Industry/TSTF Standard Technical Specification Change Traveler

Combine LCO 3.1.1 and 3.1.2

NUREGs Affected: 1430 1431 1432 1433 1434

3
Figure 3.1.3-1 (page 1 of 1)
Moderator Temperature Coefficient vs. Power Level

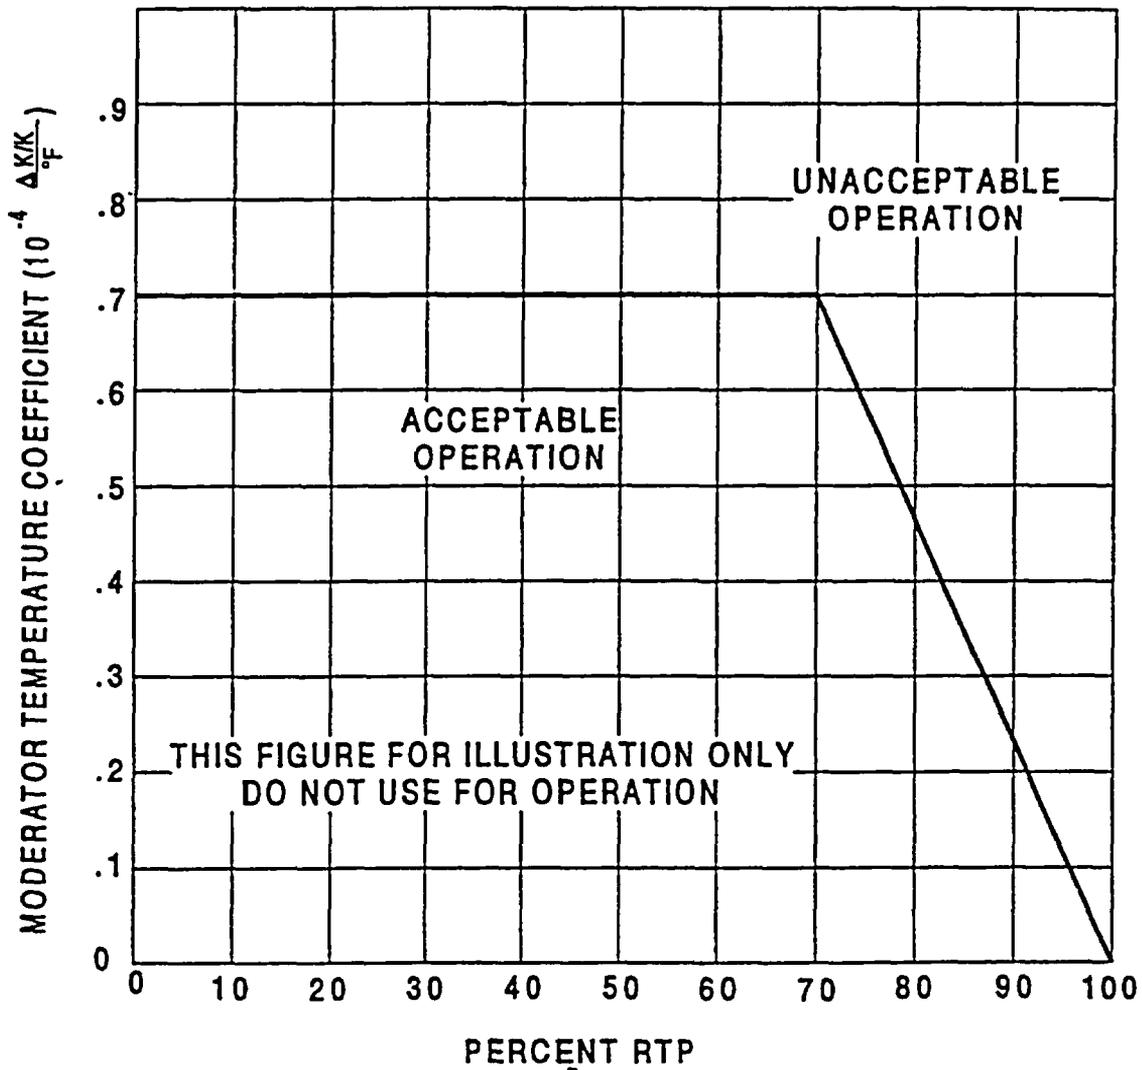
3.1.4	Moderator Temperature Coefficient Change Description: Renumbered to 3.1.3	NUREG(s)- 1431 Only
3.1.4-1	Moderator Temperature Coefficient Change Description: Renumbered Figure 3.1.4-1 to 3.1.3-1	NUREG(s)- 1431 Only

Figure B 3.1.0-1 (page 1 of 1)
Control Bank Insertion vs. Percent RTP

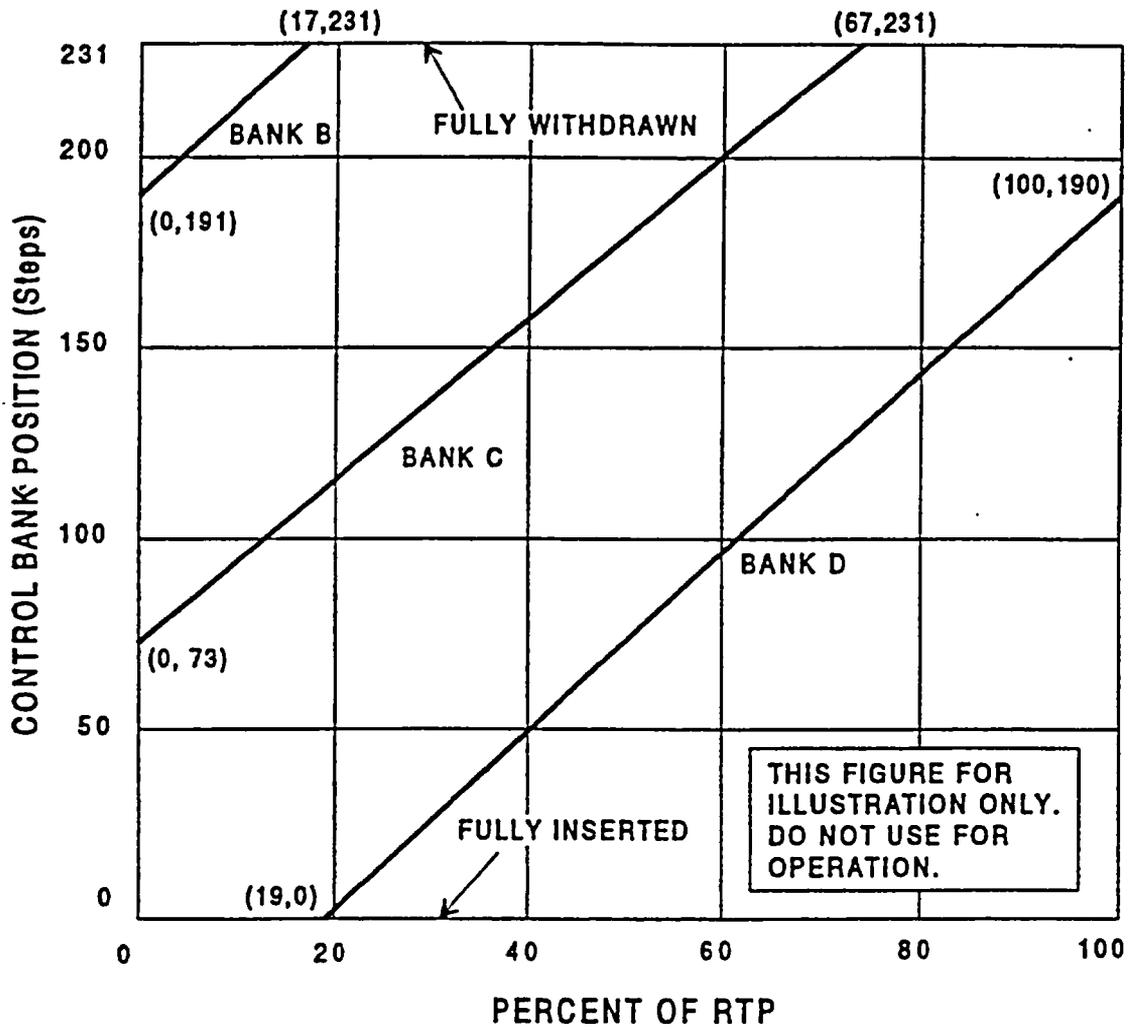
3.1.7-1 Bases	Control Bank Insertion Limits Change Description: Rename Figure 3.1.7-1 to 3.1.6-1	NUREG(s)- 1431 Only
Bkgnd 3.1.7 Bases	Control Bank Insertion Limits	NUREG(s)- 1431 Only
LCO 3.1.7	Control Bank Insertion Limits Change Description: Renumbered to 3.1.6	NUREG(s)- 1431 Only
Appl. 3.1.7	Control Bank Insertion Limits Change Description: Revised Applicability Note	NUREG(s)- 1431 Only
Appl. 3.1.7 Bases	Control Bank Insertion Limits	NUREG(s)- 1431 Only
Action 3.1.7.A Bases	Control Bank Insertion Limits	NUREG(s)- 1431 Only
SR 3.1.7.1	Control Bank Insertion Limits Change Description: Renumbered to 3.1.6.1	NUREG(s)- 1431 Only
SR 3.1.7.1 Bases	Control Bank Insertion Limits Change Description: Renumbered to 3.1.6.1	NUREG(s)- 1431 Only
SR 3.1.7.2	Control Bank Insertion Limits Change Description: Renumbered to 3.1.6.2	NUREG(s)- 1431 Only

3
Figure 3.1.0-1 (page 1 of 1)
Allowable Positive MTC Limit

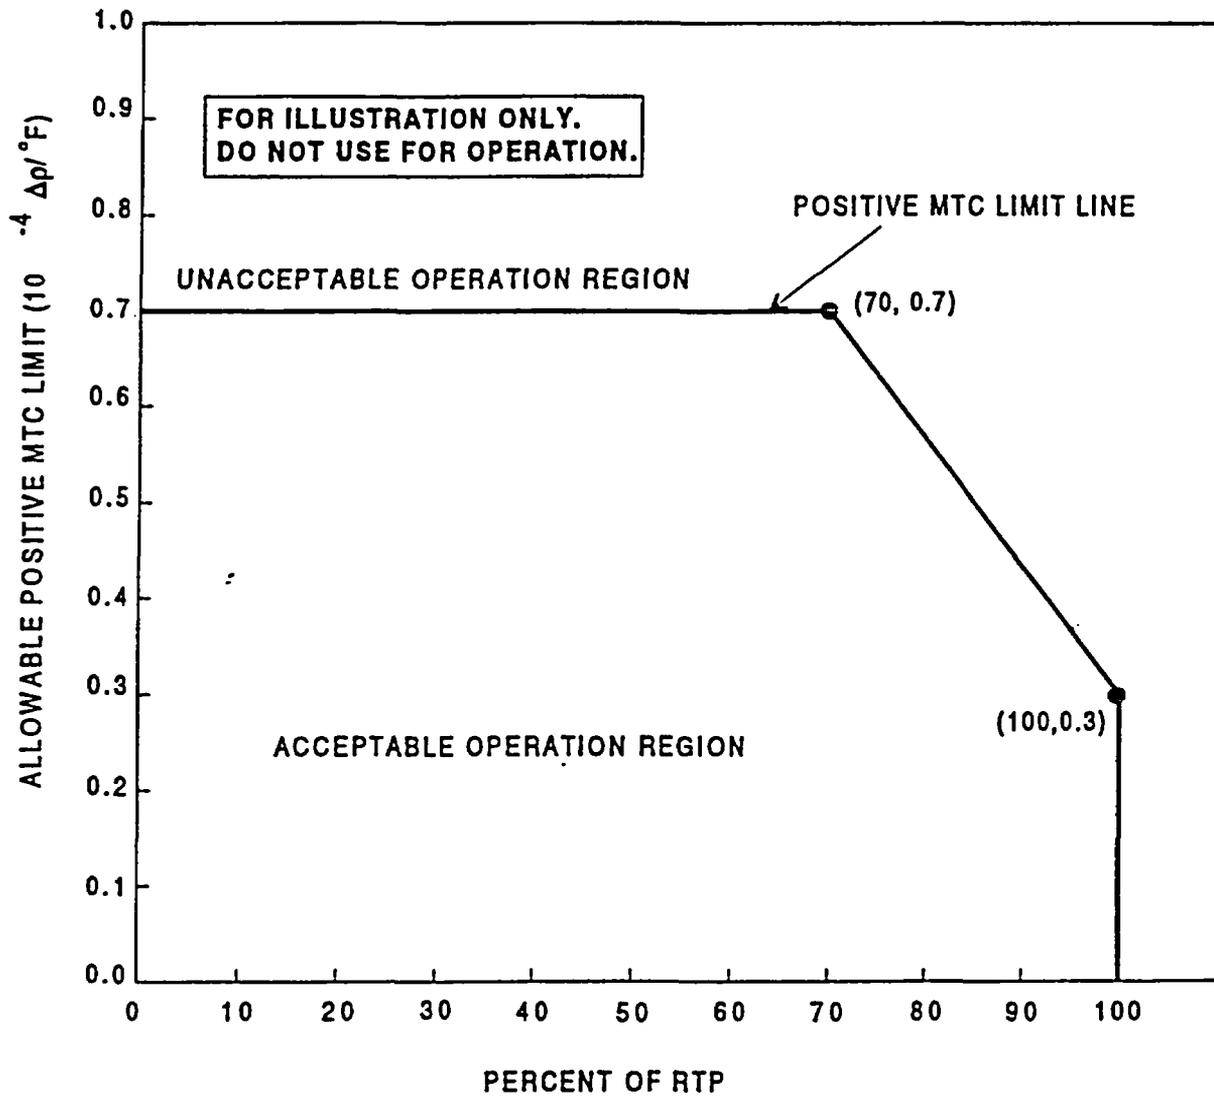
3.1.4-1	MTC (Analog) Change Description: Renumbered Figure to 3.1.3-1	NUREG(s)- 1432 Only
3.1.4	MTC (Analog) Change Description: Renumbered to 3.1.3	NUREG(s)- 1432 Only
